# Addendum No. 1

**Project:** Fort Wayne International Airport  
Construct Taxiway G Extension & Demolish Taxiway C2  
AIP No. 3-18-0022-71

**Date:** June 14, 2024

Drawing No.:  
**G4.0.1**

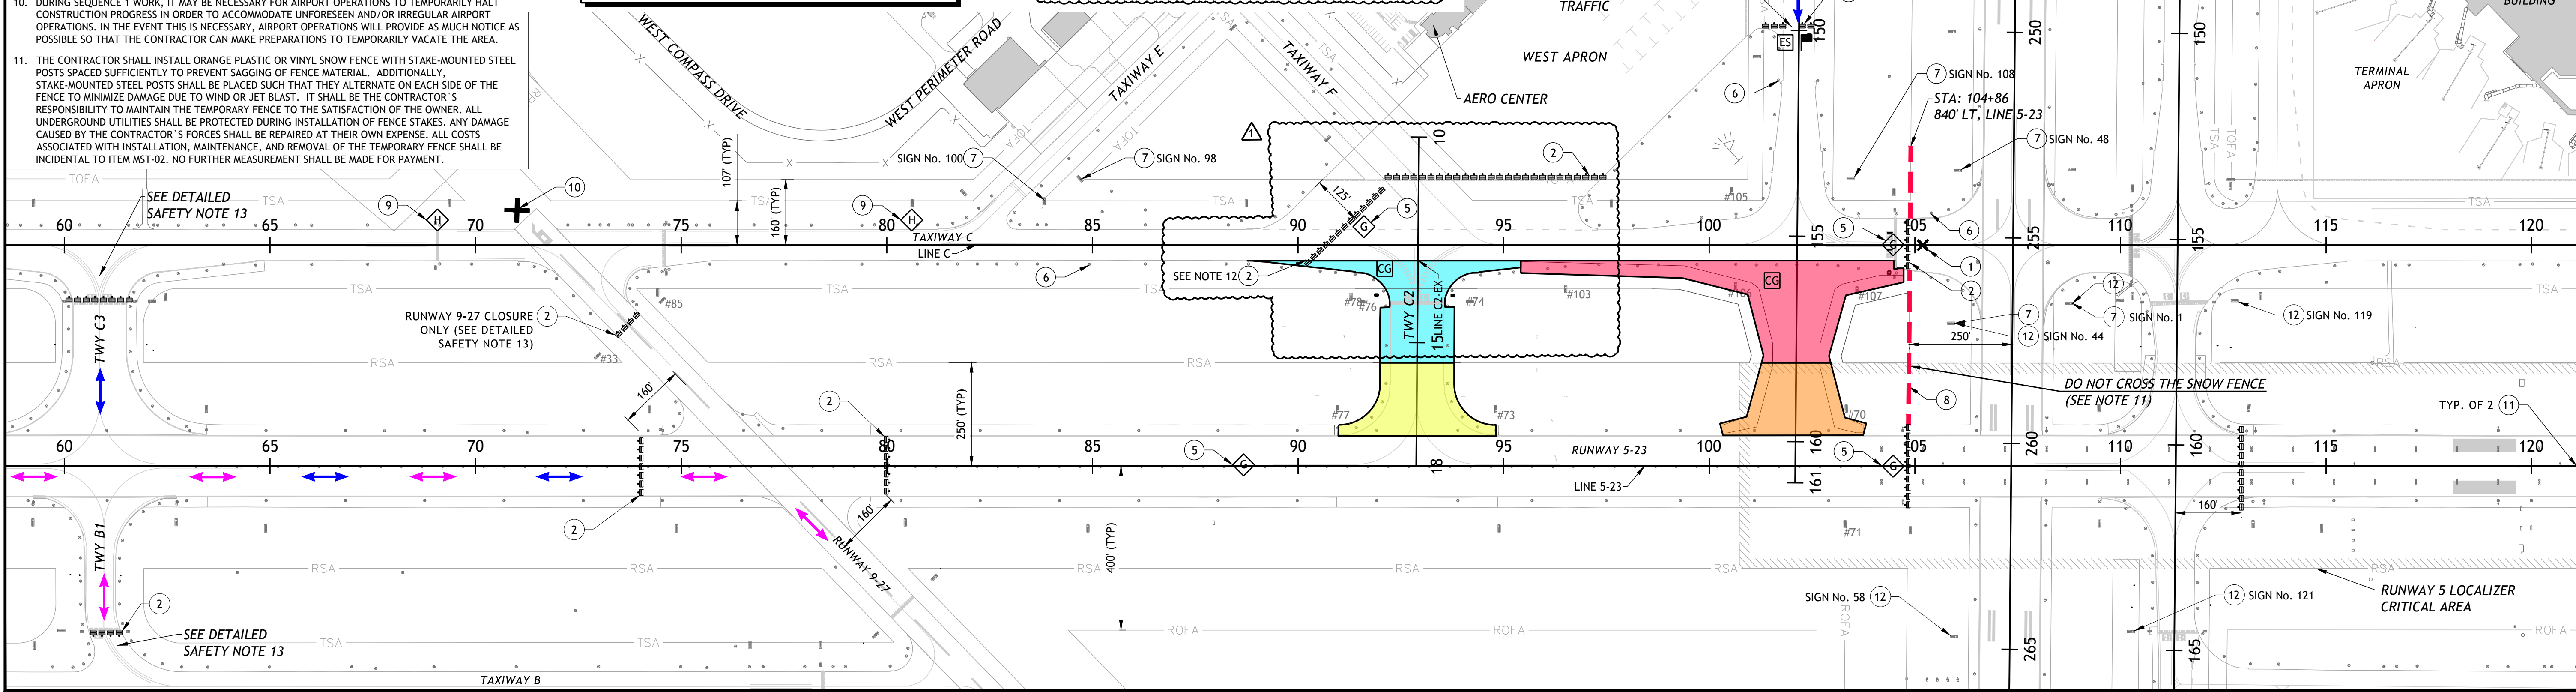
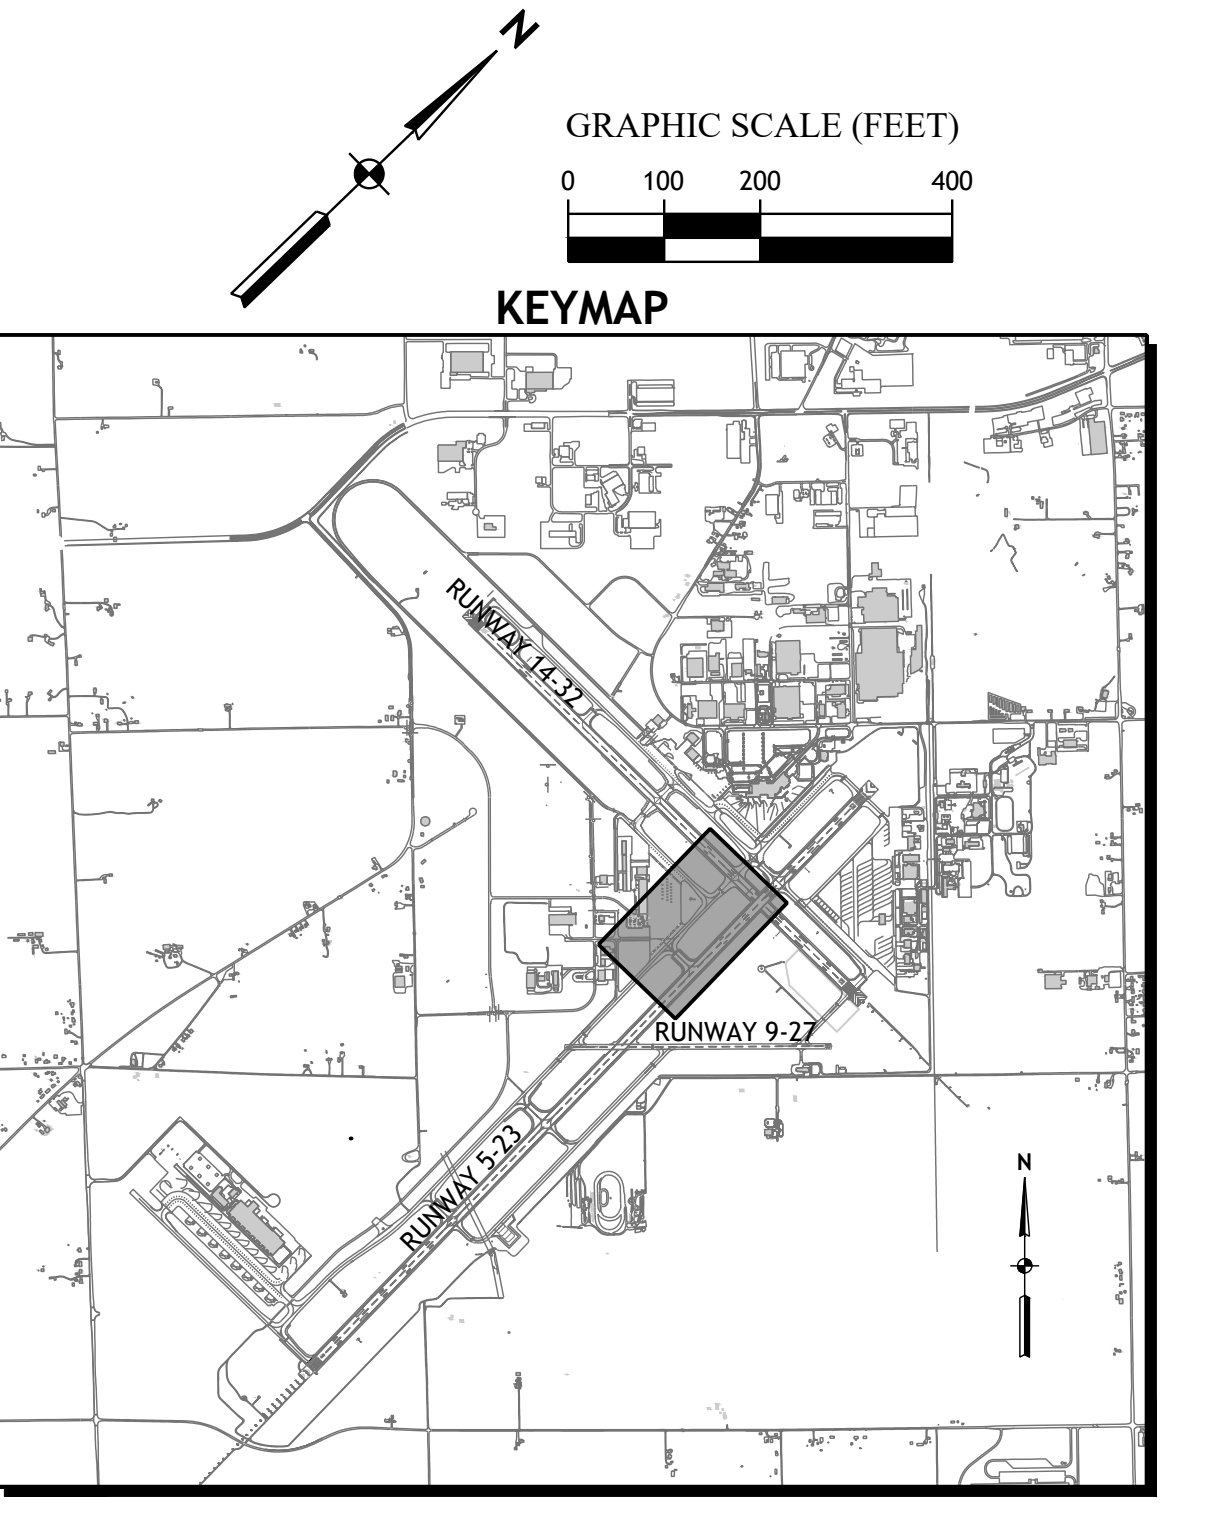
New access gates denoted for equipment and material deliveries requiring tractor-trailer and/or lowboy access may utilize Gate 15A or 17, as further noted on the plans. New General Safety Note 36 added as well for further explanation of these alternative access points.

Drawing No.: **G5.1.3**

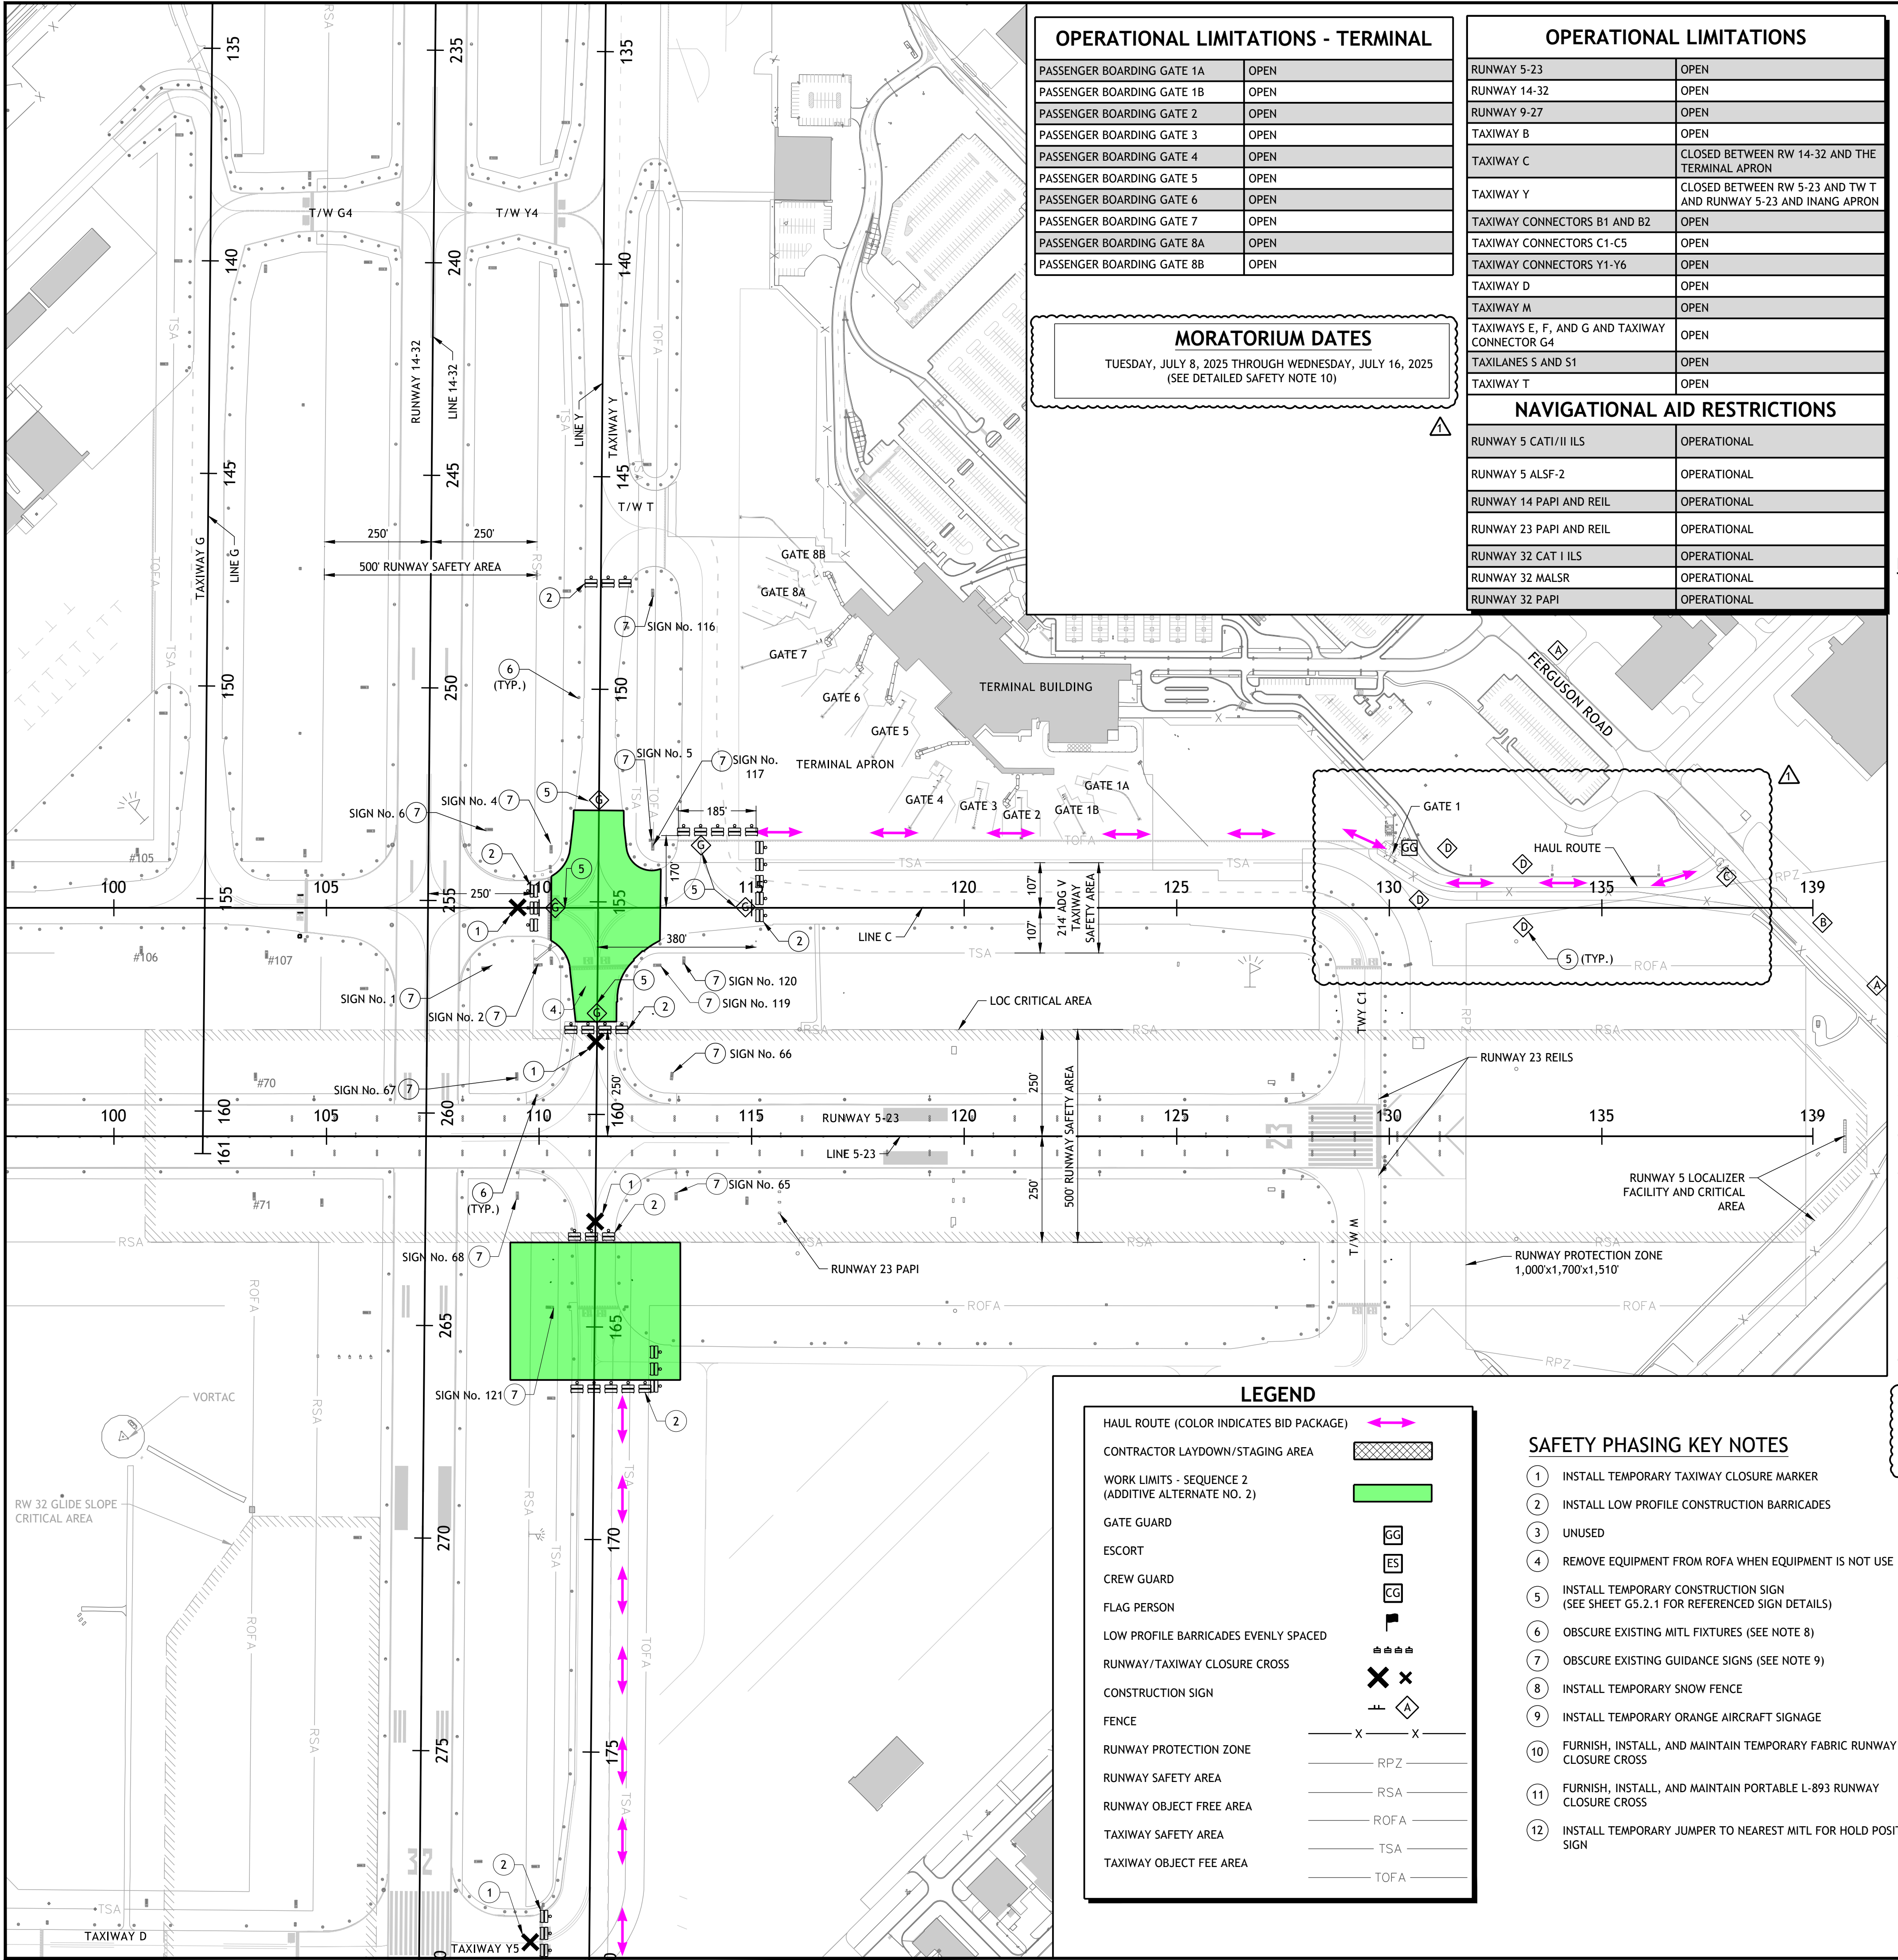
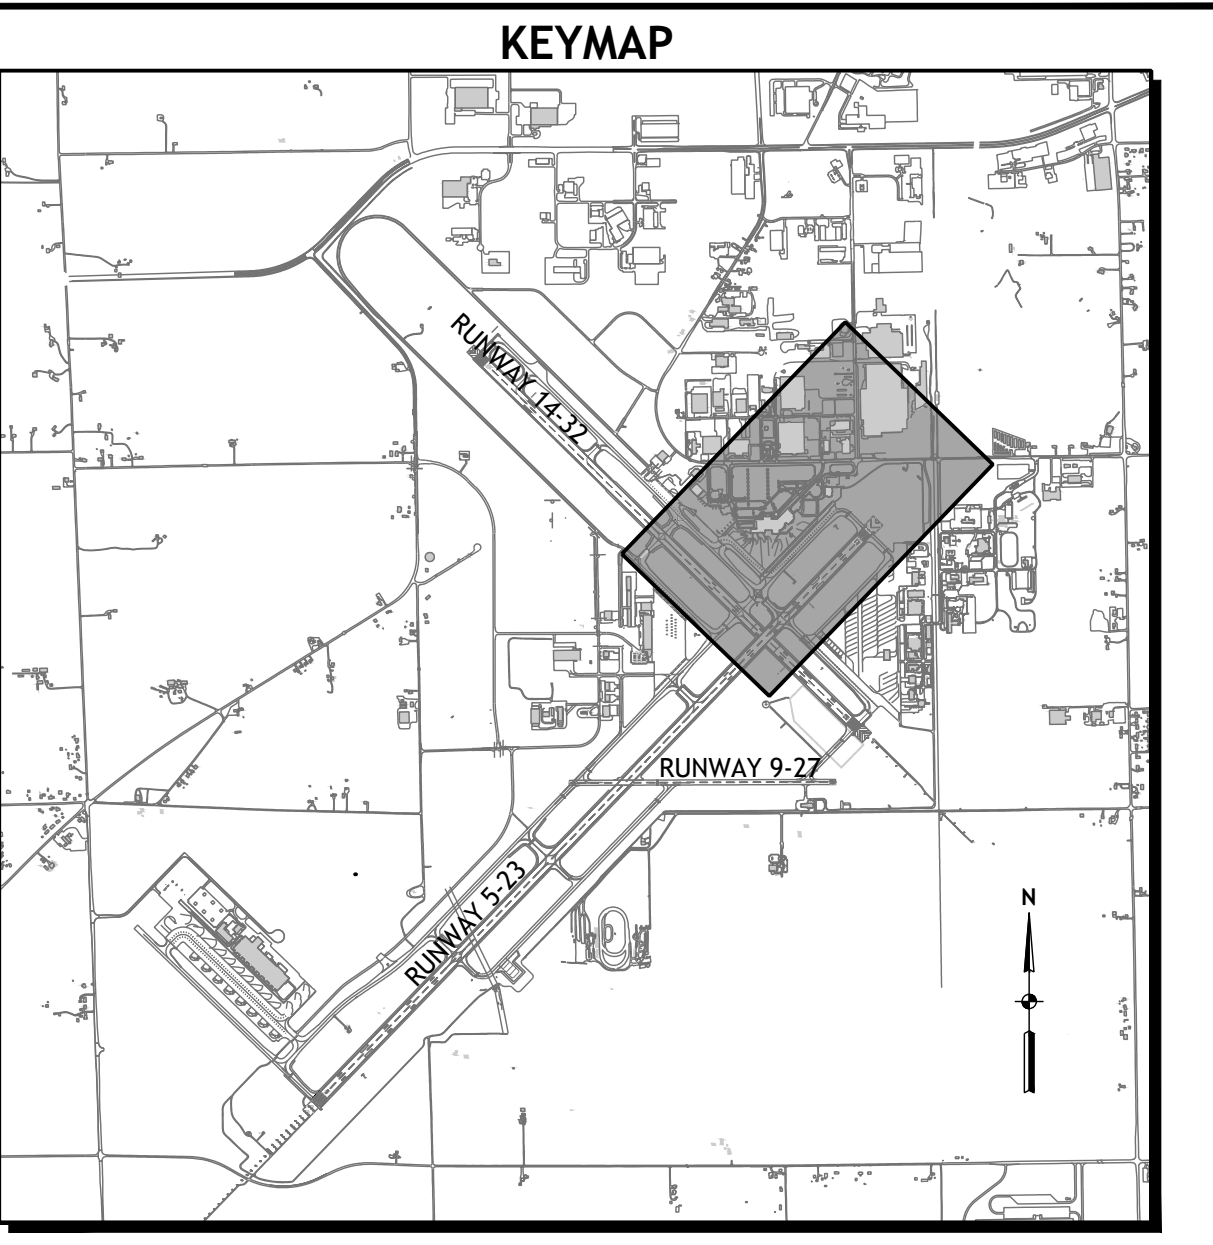
Reissued: Operational Limitation Table has been updated to reflect partial closure on Taxiway C from Taxiway E to Runway 14-32. Missing barricades have been added on Taxiway C and West Apron.

Detailed Safety Note 1 has been revised with updated notice to proceed and substantial completion dates.

Moratorium dates and new Detailed Safety Note 14 added for the 2025 Air Show has been added to the sheet. Substantial completion date has been revised to reflect incorporation of Moratorium as described above.
